**CITY OF SAINT PAUL
HERITAGE PRESERVATION COMMISSION STAFF REPORT**

FILE NAME: 5 Heather Place
APPLICANT: Jeff Arundel
OWNER: Jeff Arundel
PROJECT ARCHITECT: David Strand – Strand Design
DATE OF APPLICATION: May 13, 2019
DATE OF PUBLIC HEARING: June 3, 2019
HPC DISTRICT: Historic Hill Heritage Preservation District
PERIOD OF SIGNIFICANCE: 1857-1930
CATEGORY: Pivotal **WARD:** 2 **DISTRICT COUNCIL:** 16
CLASSIFICATION: New Construction
BUILDING PERMIT #: 19-040017
STAFF INVESTIGATION AND REPORT: Allison Suhan
DATE: May 23, 2019

B. PROPOSED CHANGES: The applicant proposes to construct a three stall detached garage and driveway to the east of the residence. The proposed garage will be of stucco with limestone on the west elevation, have a wood shake roof to match the house with an 8/12 pitched hipped roof, stepped wood fascia and corbels, wood trim to match the finish and color of the main house, and three wood overhead doors with lites to match the garage doors at 7 Heather Place. Architectural windows and a man door are proposed on the south elevation. A driveway made of Pine Hall 'Rumbled Rose' pavers is also proposed.

ELEVATIONS

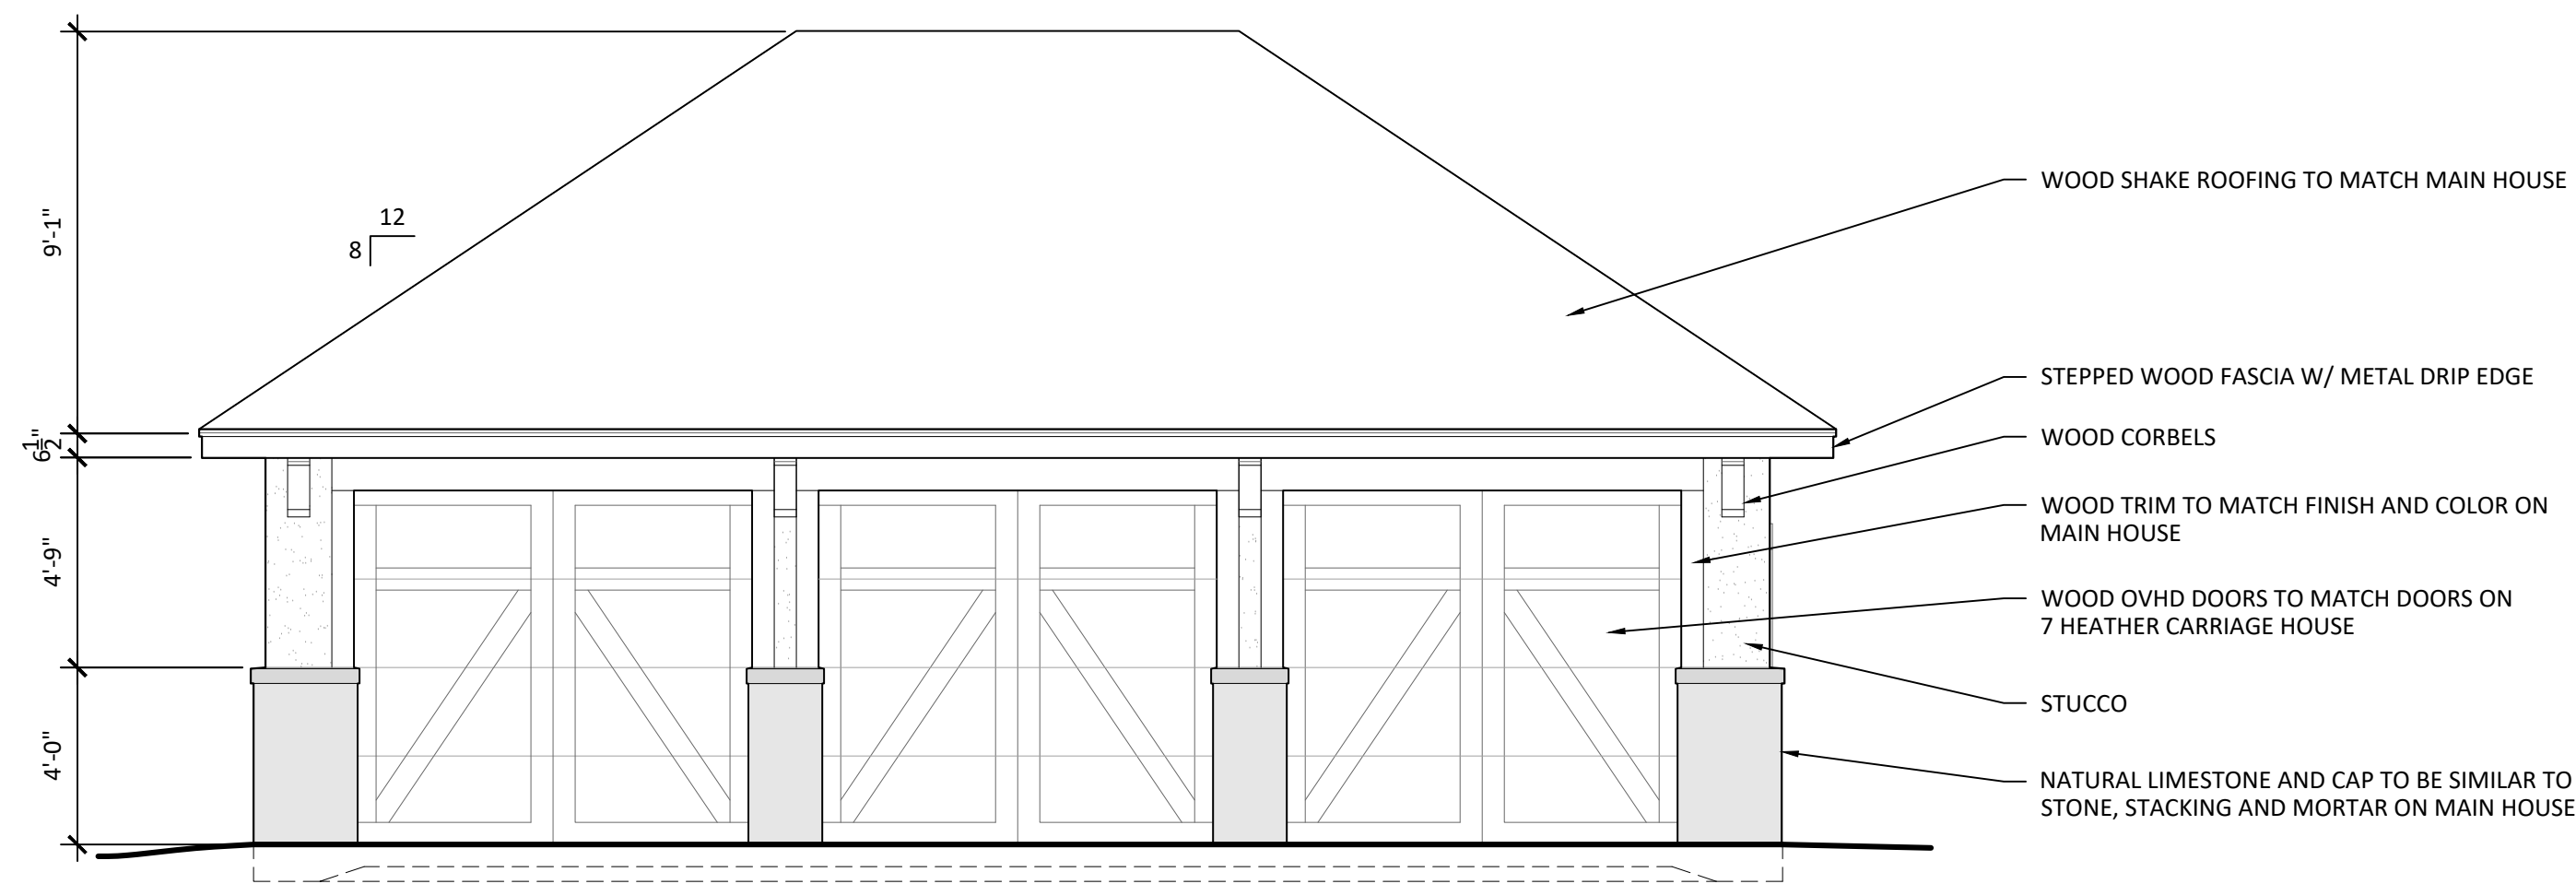
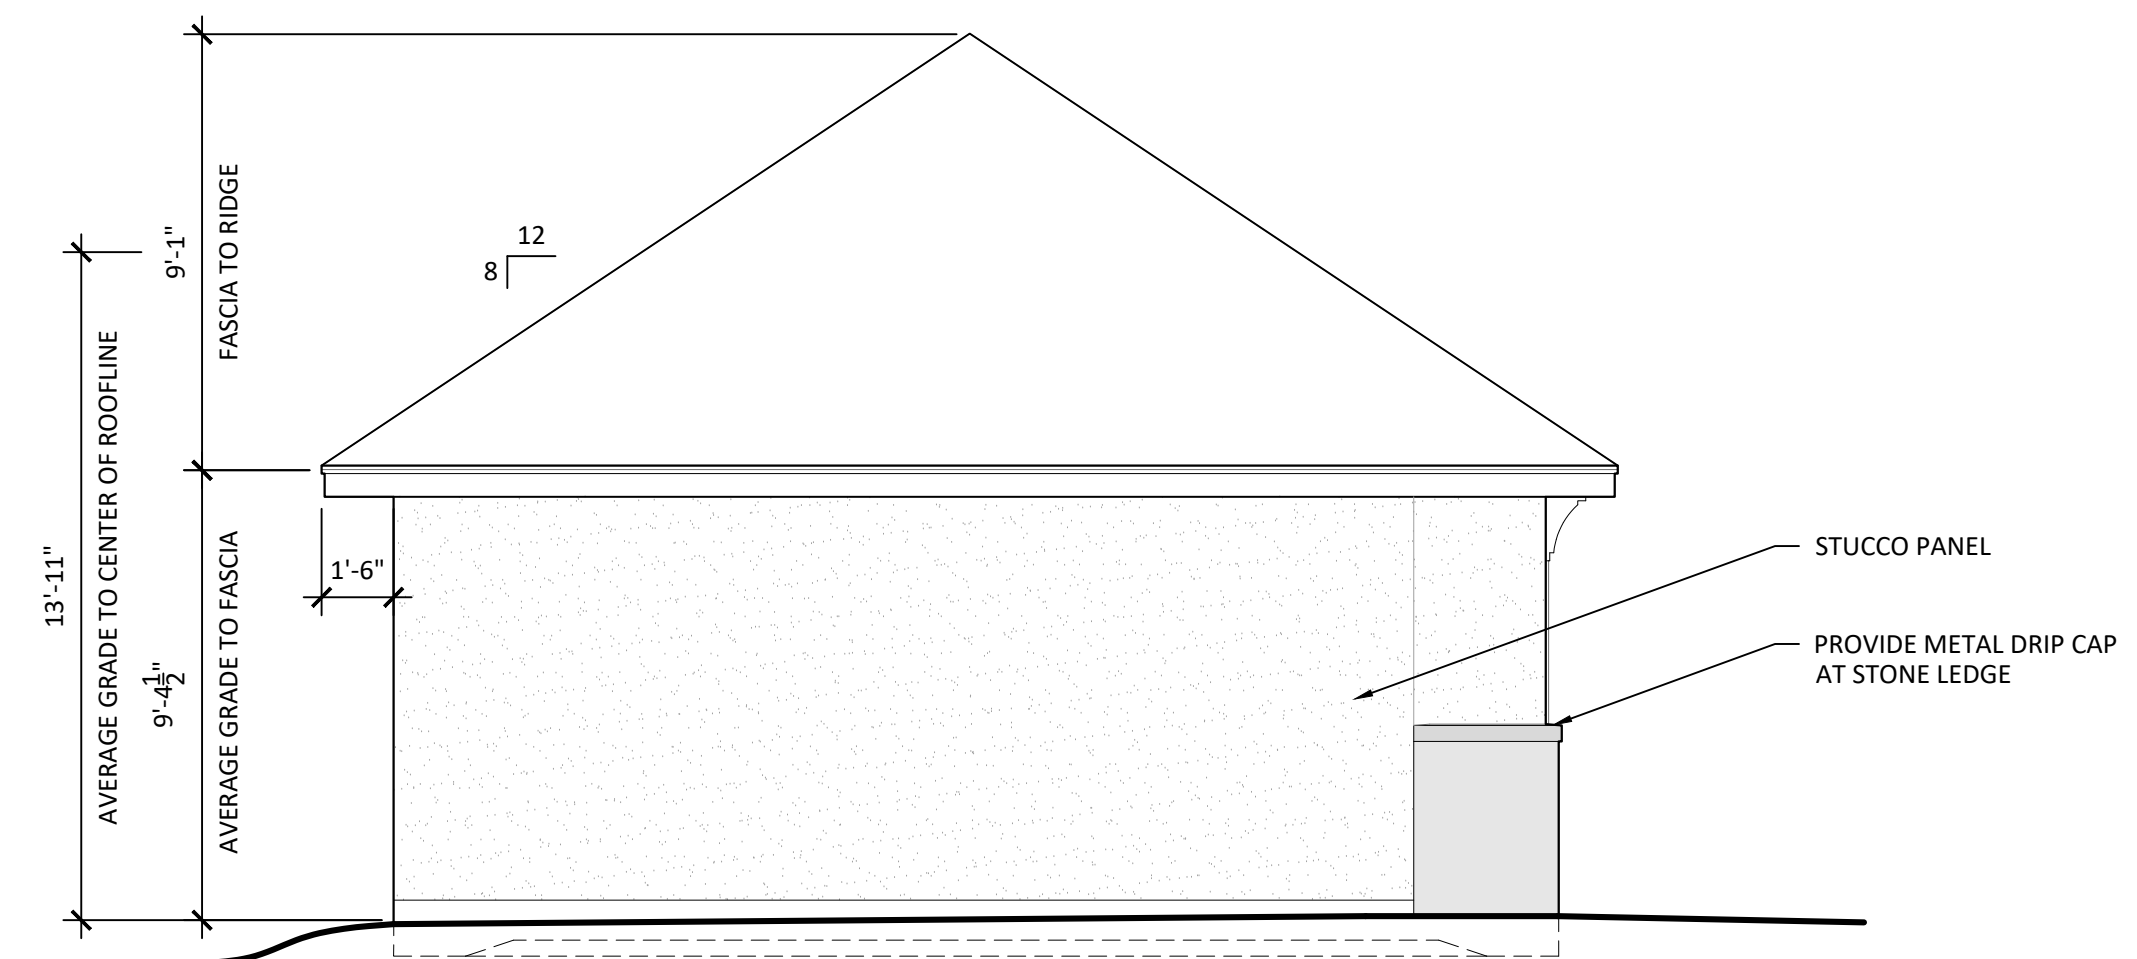
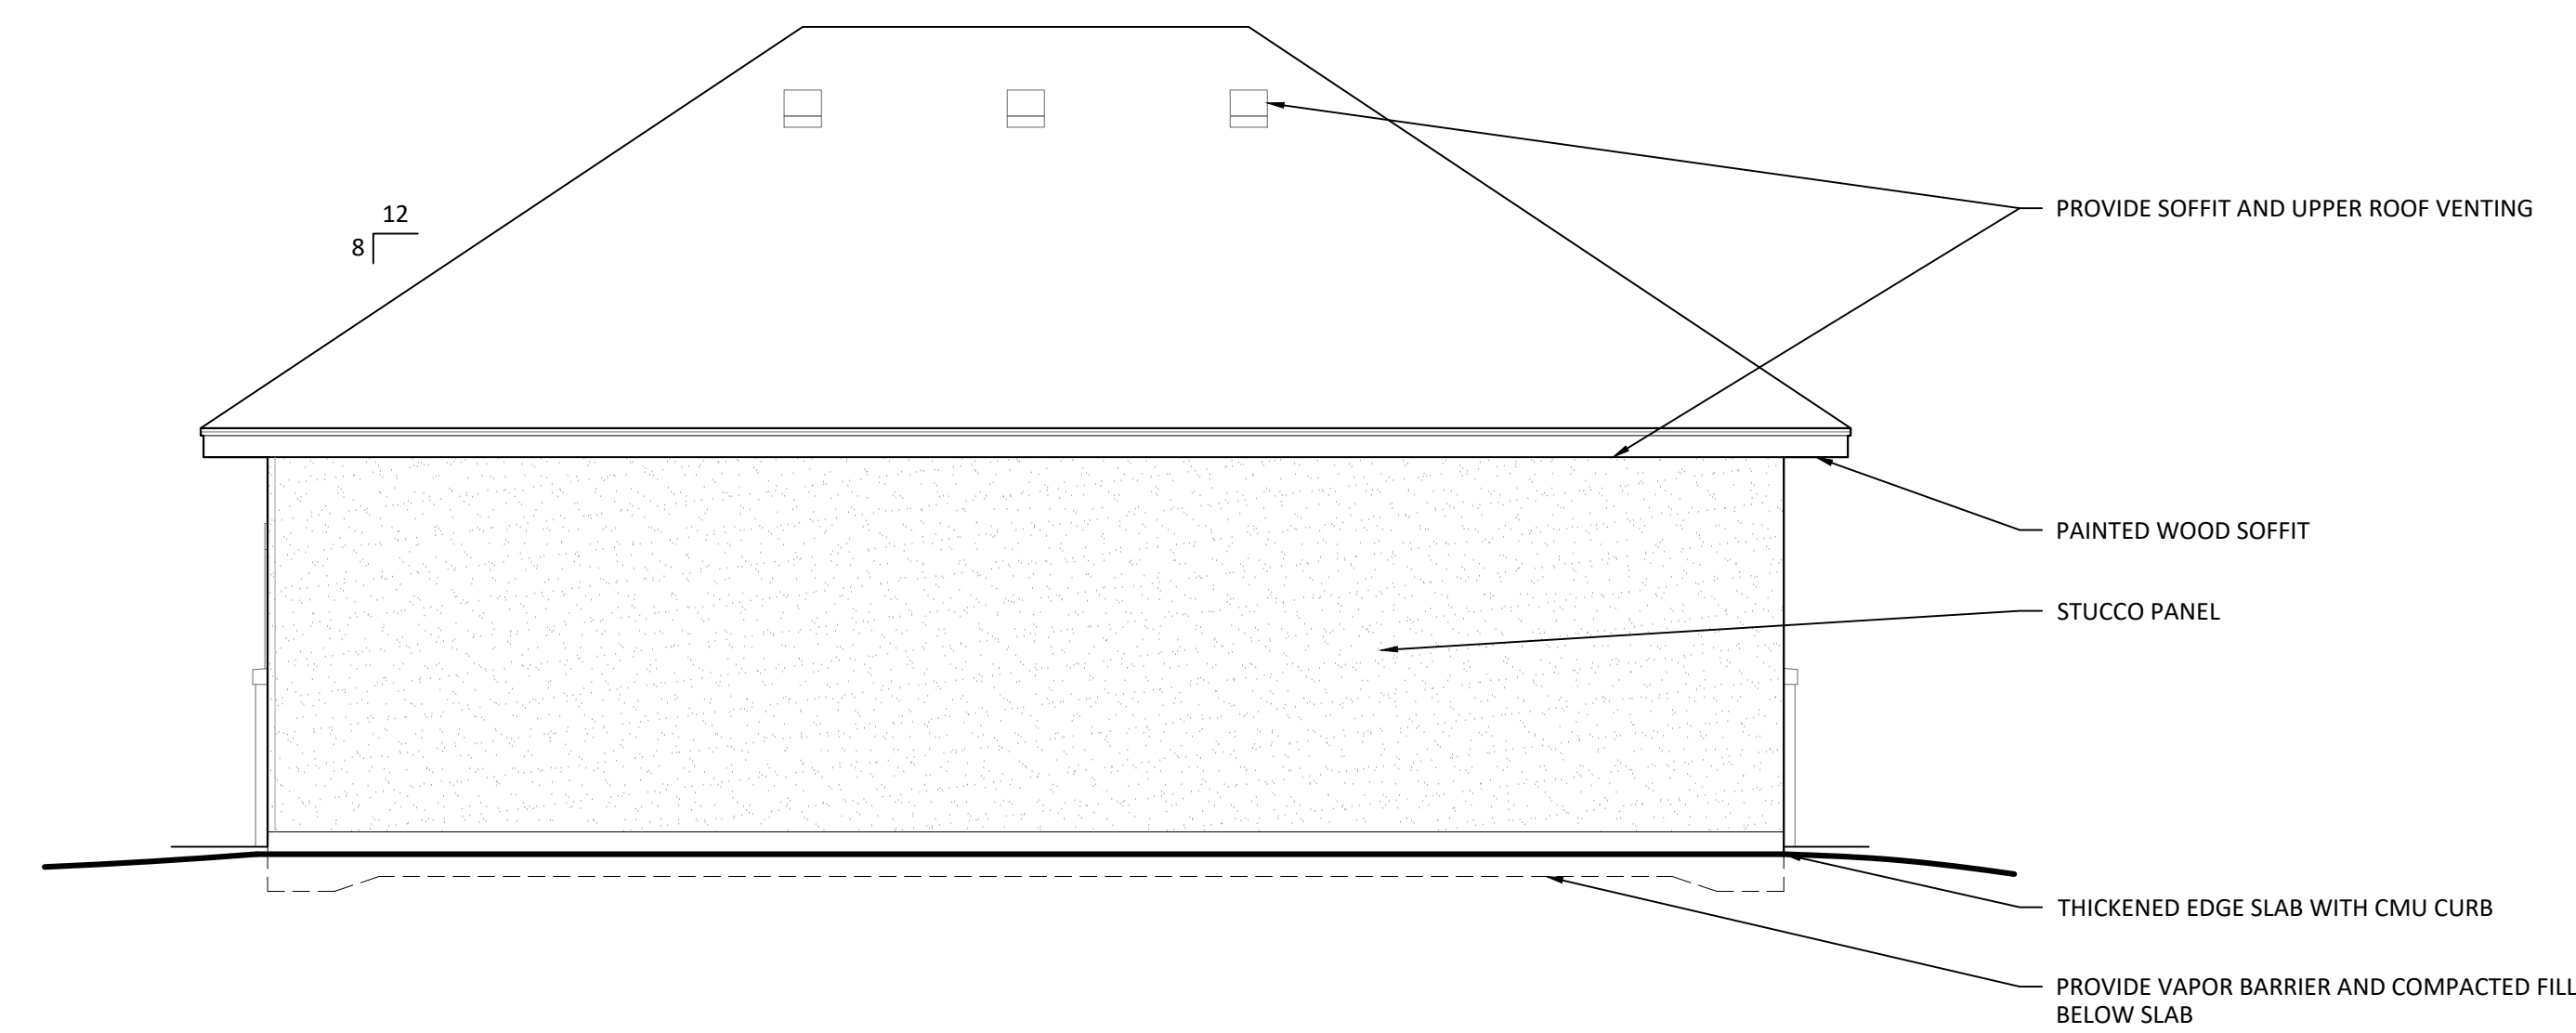
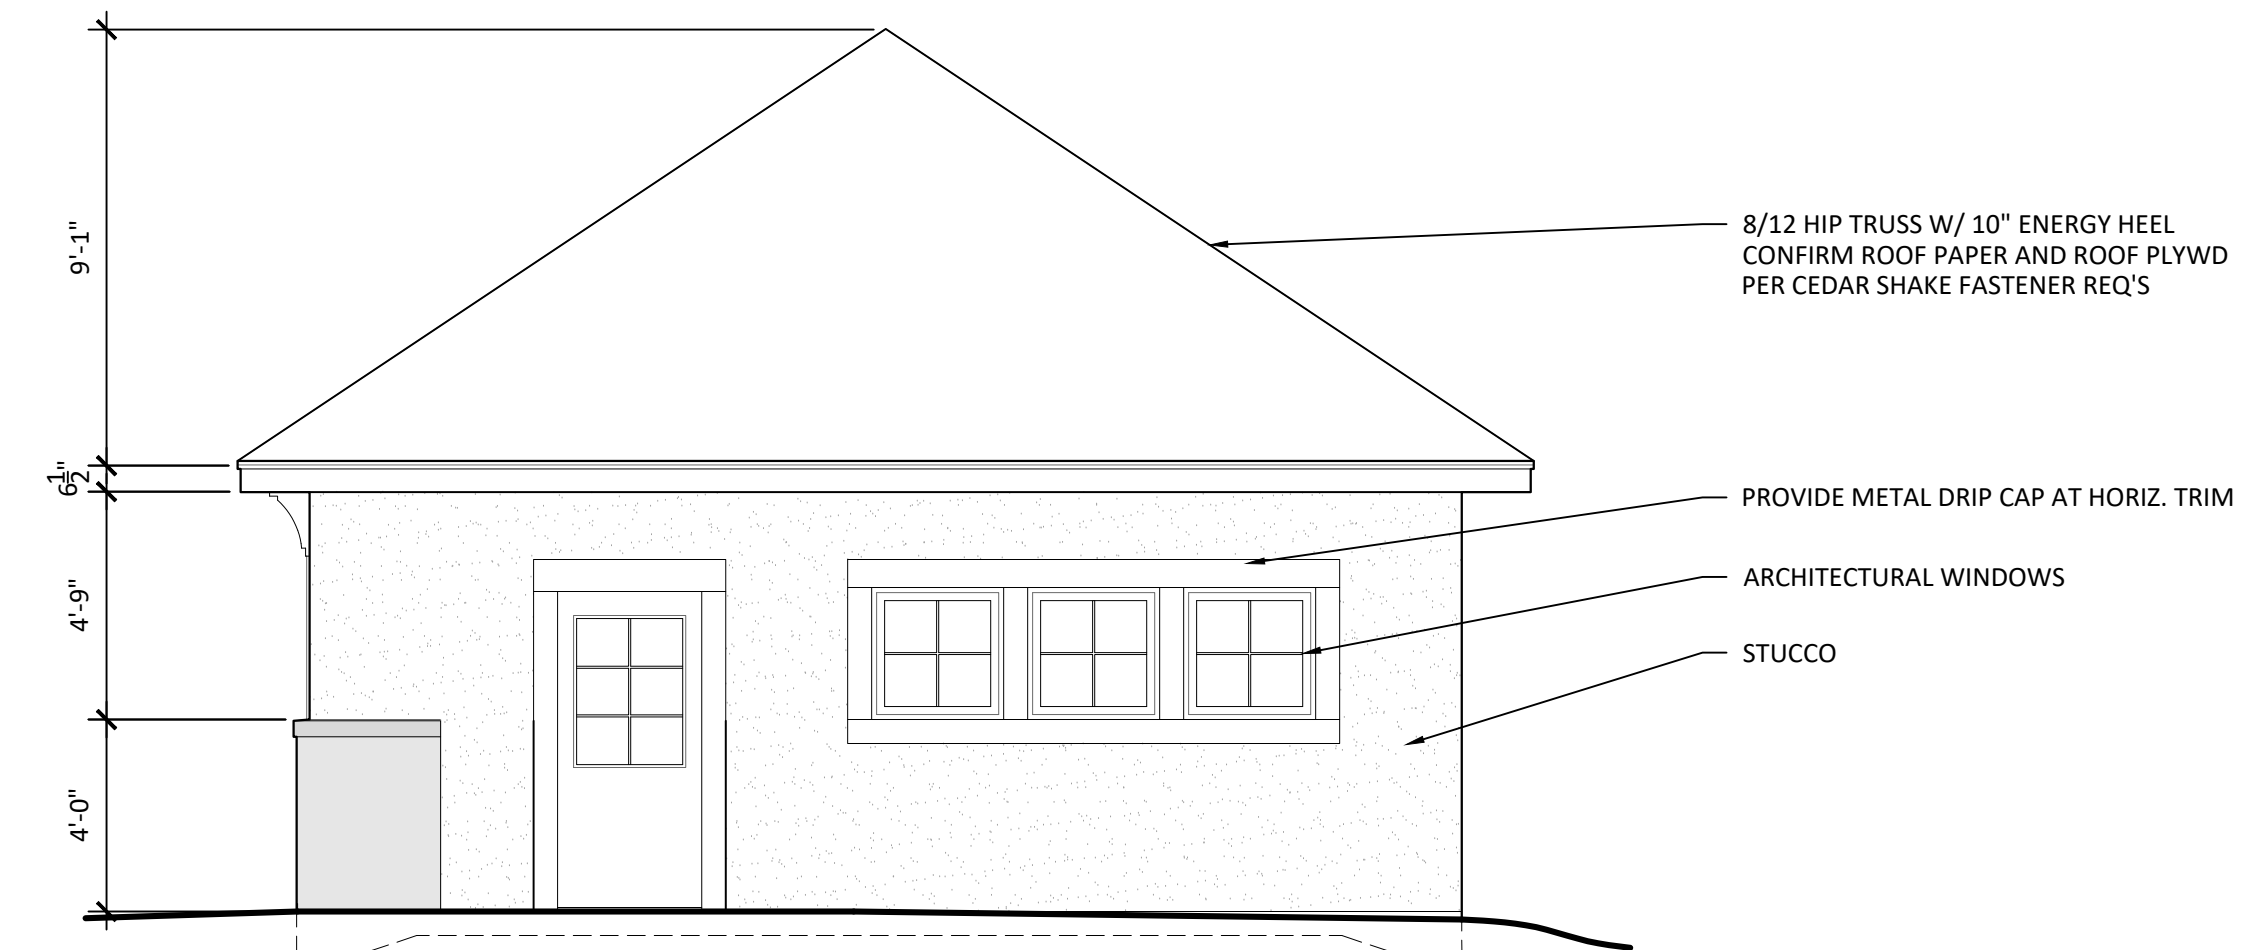
<p>(e) (1) <i>Roofs:</i></p> <p>a. There is a great variety of roof treatment in the Historic Hill District, but gable and hip roofs are most common. The skyline or profile of new construction should relate to the predominant roof shape of existing adjacent buildings.</p> <p>b. Most houses in the Historic Hill District have a roof pitch of between 9:12 and 12:12 (rise-to-run ratio). Highly visible secondary structure roofs should match the roof pitch of the main structure, and generally should have a rise-to-run ratio of at least 9:12. A roof pitch of at least 8:12 should be used if it is somewhat visible from the street, and a 6:12 pitch may be acceptable in some cases for structures which are not visible from the street.</p> <p>c. Roof hardware such as skylights, vents and metal pipe chimneys should not be placed on the front roof plane.</p>	<p>Yes</p>	<p><i>He 8:12 hipped wood shingled roof complies with the guideline. Roof vents are proposed on the rear (east) elevation.</i></p>

<p>(f) <i>Site:</i></p> <p>(1) <i>Setback.</i> New buildings should be sited at a distance not more than five (5) percent out-of-line from the setback of existing adjacent buildings. Setbacks greater than those of adjacent buildings may be allowed in some cases. Reduced setbacks may be acceptable at corners. This happens quite often in the Historic Hill area and can lend delightful variation to the street.</p>	<p>Yes</p>	<p><i>The proposed garage is setback from the street as well as neighboring structures.</i></p>
<p>(f)(3) <i>Garages and parking:</i></p> <p>a. If an alley is adjacent to the dwelling, any new garage should be located off</p>	<p>Yes</p>	<p><i>The proposed garage faces the street, but has three individual garage doors and complies with</i></p>

the alley. Where alleys do not exist, garages facing the street or driveway curb cuts may be acceptable. Garage doors should not face the street. If this is found necessary, single garage doors should be used to avoid the horizontal orientation of two-car garage doors.		<i>the guideline.</i> <i>The proposed driveway will be made of Pine Hall 'Rumbled Rose' pavers that relate to the historic brick turn around in front of the residence.</i>
(C.F. No. 05-52, § 2, 2-23-05)

1. All final materials, colors, details and finishes and shall be submitted to the HPC and/or staff for final review and approval including but not limited to masonry, mortar, balcony and guardrail details, hardscaping, window and door brands, styles, and finishes. A mock-up shall be constructed on site for a design review committee of the HPC to review and approve.
